1980 Corvette: Service Bulletin: Rear Wheel Spindle Yoke Snapping Noise

Source: Chevrolet Dealer Service Technical Bulletin

Bulletin No: 80-T-44

Date: June, 1980

FIGURE 1

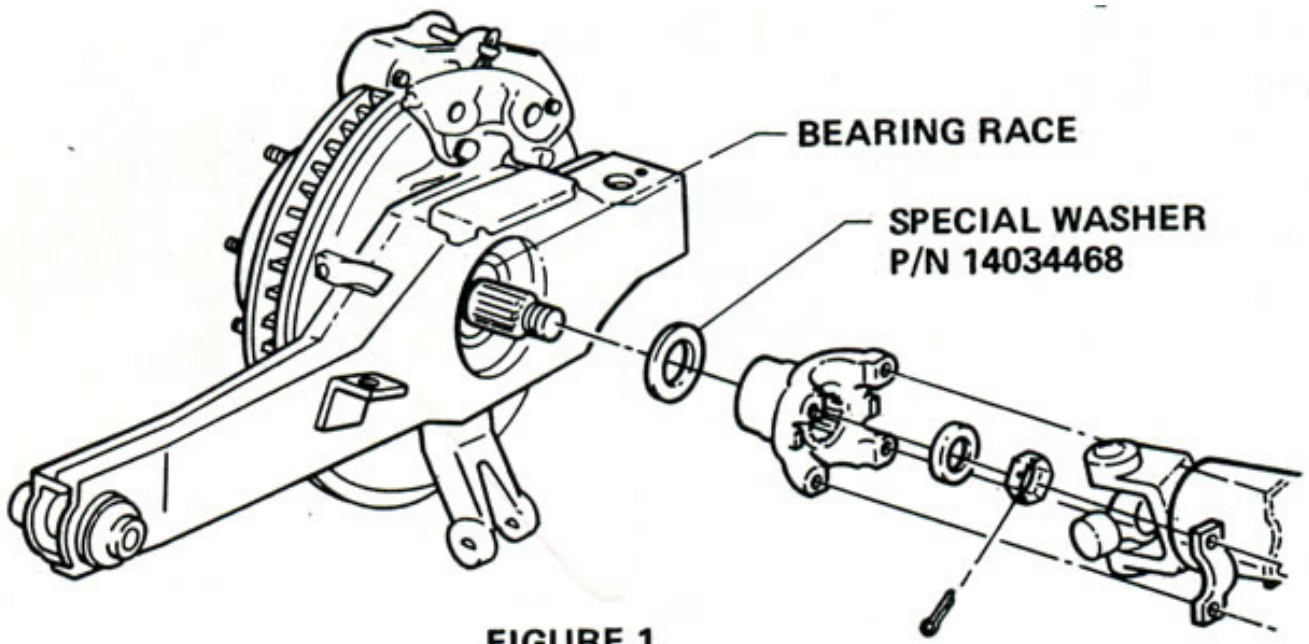
Owners of 1980 Corvettes, primarily those equipped with a manual transmission, may experience a snapping or crunching noise from either or both rear wheel locations during torque reversals and during acceleration or deceleration. This noise is the result of scuffing of the rear wheel spindle yoke against the inner wheel bearing inner race.

This condition can be corrected by installing a special Moly coated washer (P/N 14034468) between the spindle yoke and the inner wheel bearing (see Figure 1). Steps 2 through 8 of the following Service Procedure should be performed at each rear wheel.

FIGURE 2

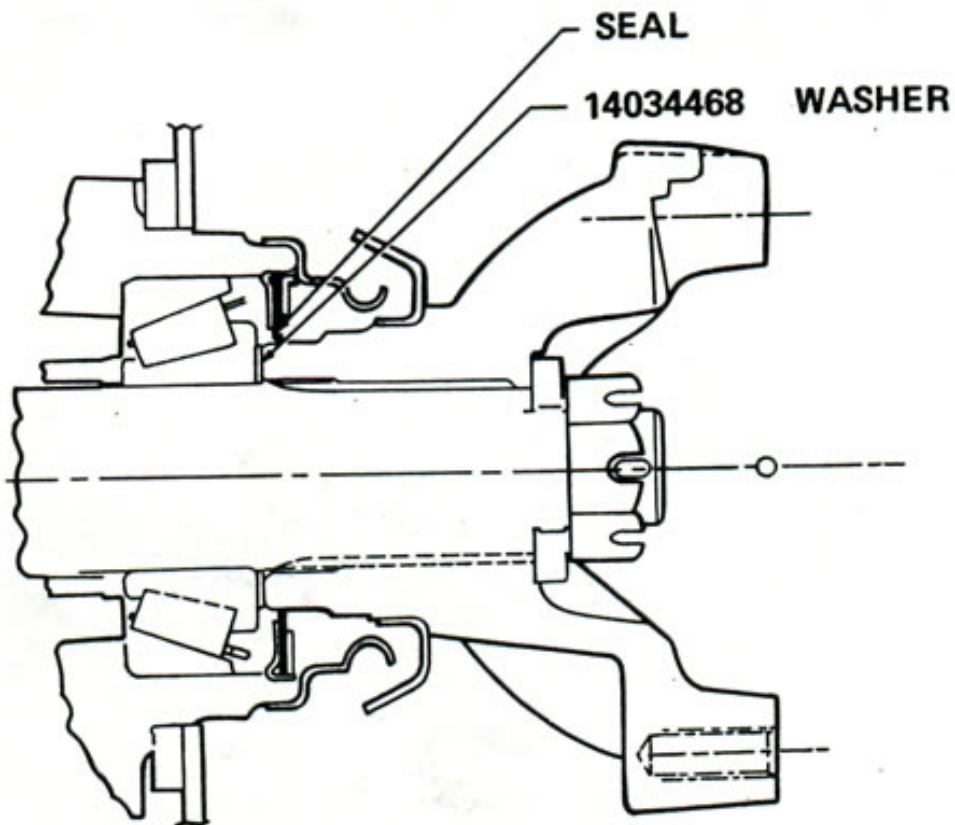
6. Install lubricated washer and spindle yoke on spindle such that washer is between yoke and the inner wheel bearing and completely inside the seal (see Figure 2). NOTE: Use care to avoid nicking the seal lip or trapping it between the washer and the bearing race. If the seal life is damaged, the seal must be replaced.
